ALERT SERVICE BULLETIN

205-21-119

MODEL AFFECTED: 205A/205A-1

SUBJECT: MAIN ROTOR SCISSORS & SLEEVE HUB
ASSEMBLY COLLECTIVE 204-011-405-013
IDENTIFICATION

Figure 1 – Hub Assembly Ink-Stamped Part Number and Serial Number

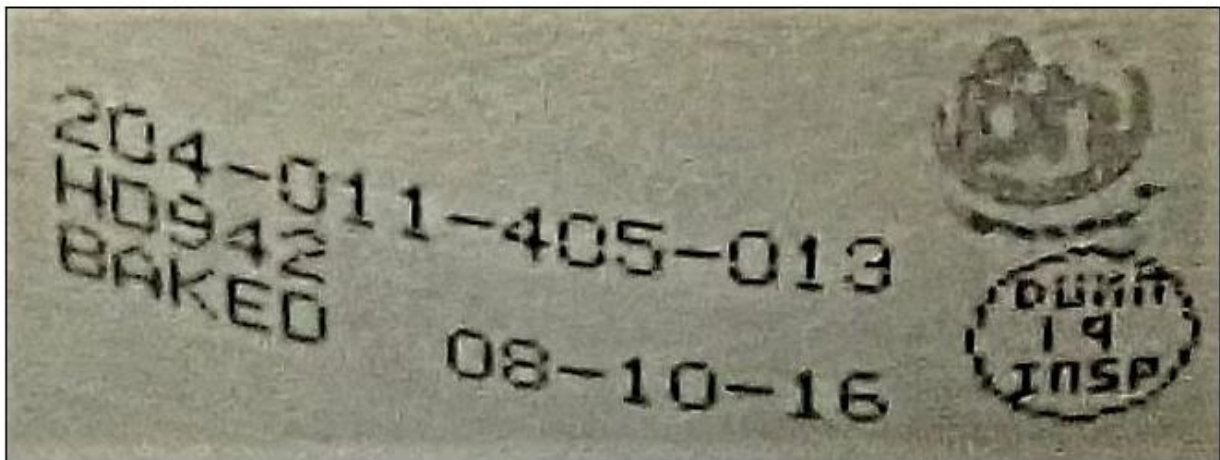
3. Gain access to the Hub Assembly 204-011-405-013 and inspect for the presence of part number and serial number matching the Historical Service Record (HSR) at the location shown on Figure 1.
4. If the Hub Assembly is not correctly marked, as shown in Figure 1, proceed with **PART II**.
5. If the Hub Assembly is correctly marked, as shown in Figure 2, make an entry in the helicopter logbook and historical service records indicating findings and compliance with **Part I** of this Alert Service Bulletin.
6. If **Part II** of this ASB is not going to be accomplished immediately, make an entry in the helicopter logbook and historical service records indicating compliance with **Part I** of this Alert Service Bulletin with an annotation to accomplish **Part II** within the required compliance time stated in this ASB.

Maximum depth of vibro-etching or dot-peening shall not exceed 0.005-inch (.127 mm). Part and serial numbers shall be marked in the scalloped area of the hub as shown in Figure 2 of this ASB; to a minimum height of 0.062-inch (1.57 mm) and no closer than 0.100-inch (2.54 mm) to any edge.

2. If the Hub Assembly has an ink-stamped part and serial number matching the HSR (refer to example shown in Figure 1), permanently mark the part and serial number on the Hub Assembly by vibro-etching or dot-peening (Figure 2).
3. If the Hub Assembly does not have a part number and serial number, create a unique serial number for each Hub Assembly. Using one or two prefix letters consistent with the company name of the operator or repair facility accompanied by a dash and 4 or 5 digits is considered as an industry serial number marking standard. Vibro-etch or dot-peen the Hub Assy with the part number and the assigned serial number (Figure 2).
